UNITED STATES PATENT AND TRADEMARK OFFICE

APPLICATION NO.	FILING DATE	FIRST NAMED INVENTOR	ATTORNEY DOCKET NO.	CONFIRMATION NO.
10/573,543	03/27/2006	Danut Bogdan	2003P13768	7334
24131	7590	11/17/2006	EXAMINER	
LERNER GREENBERG STEMER LLP			CRUZ, LESLIE PILAR	
P O BOX 2480			ART UNIT	PAPER NUMBER
HOLLYWOOD, FL 33022-2480			2826

Office Action Summary	Application No. 10/573,543	Applicant(s) BOGDAN ET AL.	
	Examiner Leslie P. Cruz	Art Unit 2826

DETAILED ACTION***Drawings***

FIG. 9 (b)

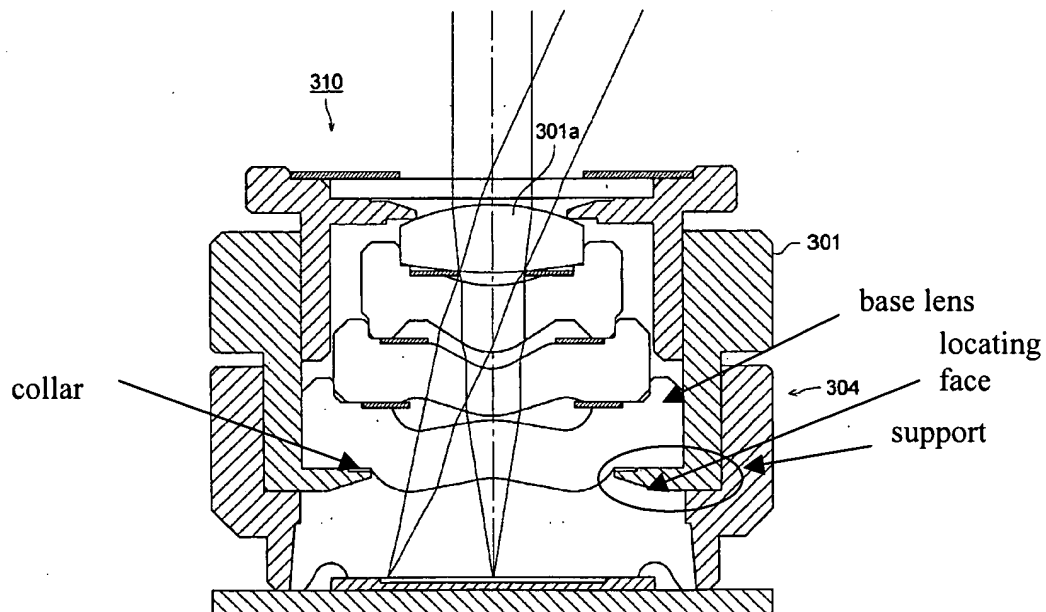
With respect to claim 10, Tansho (e.g. Figs. 1-2, 6 and 9 (b)) discloses an optical module comprising: a circuit carrier [PC]; a semiconductor element disposed in a housing [304] disposed on the circuit carrier, the housing of the semiconductor element, at least in sections thereof, having a support (see figure below) formed thereon; and a lens unit [301a] configured for projecting electromagnetic radiation onto the semiconductor element; wherein the semiconductor element and the lens unit are formed in two parts, and the lens unit is supported on the support formed on the housing of the semiconductor element.

Tansho (e.g. Fig. 9) discloses the support is formed to be tilt-free.

Tansho (e.g. Fig. 9) discloses the lens unit includes a base lens (see figure above) and the lens unit is supported on the base lens.

Tansho (e.g. Fig. 9) discloses the base lens includes a surface section formed to correspond to the support, at least in sections thereof, and wherein the surface section is positioned on the support formed on the housing of the semiconductor element.

With respect to claim 15, Tansho discloses the optical module according to claim 13. Tansho (e.g. Fig. 9) further discloses the base lens has a collar, at least in sections thereof, formed to correspond substantially to a locating face formed on the support.

With respect to claim 19, Tansho discloses the optical module according to claim 10. Tansho (e.g. Fig. 9) further discloses the support is formed with a locating face, at least in sections thereof.

With respect to claim 20, Tansho discloses the optical module according to claim 19. Tansho (e.g. Fig. 9) further discloses the locating face (see figure above) of the support is formed with a taper from the semiconductor element in a direction of an optical axis of the optical module.

With respect to claim 21, Tansho discloses the optical module according to claim 20. Tansho (e.g. Fig. 9) further discloses the taper is conical.
